Specific Design Plan Parkside, Section 4

SDP-1601-03

STAFF REPORT

SUBJECT: Specific Design Plan SDP-1601-03
 Type II Tree Conservation Plan TCPII-014-2016-03
 Parkside, Section 4

Figure 4: Proposed Freestanding Sign

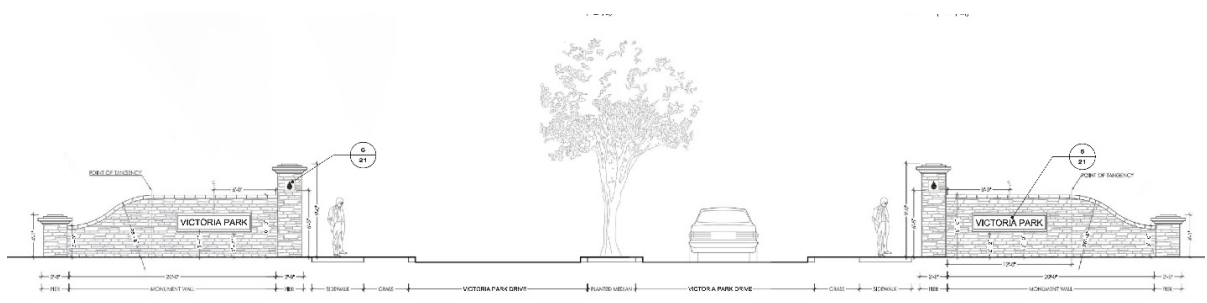
The SDP proposes two freestanding monument signs at the intersection of Rock Spring Drive and Victoria Park Drive at the primary western entrance to the development. The monument signs are approximately 6 feet high and 20 feet wide. The sign is constructed with stone veneer and includes 7-foot-high columns on each end with a central concrete plaque for the community's name. The sign is externally illuminated using up-lighting. The sign appears to be generally acceptable, and landscaping is proposed along the base and behind the sign. Staff recommends that attractive year-round landscaping be proposed at the base of the sign to enhance the proposed signage, as conditioned herein. In addition, staff notes that a schedule has not been provided listing the square footage of the proposed sign. Therefore, a condition has been included in the Recommendation section of this report requiring that a signage area calculation be provided.
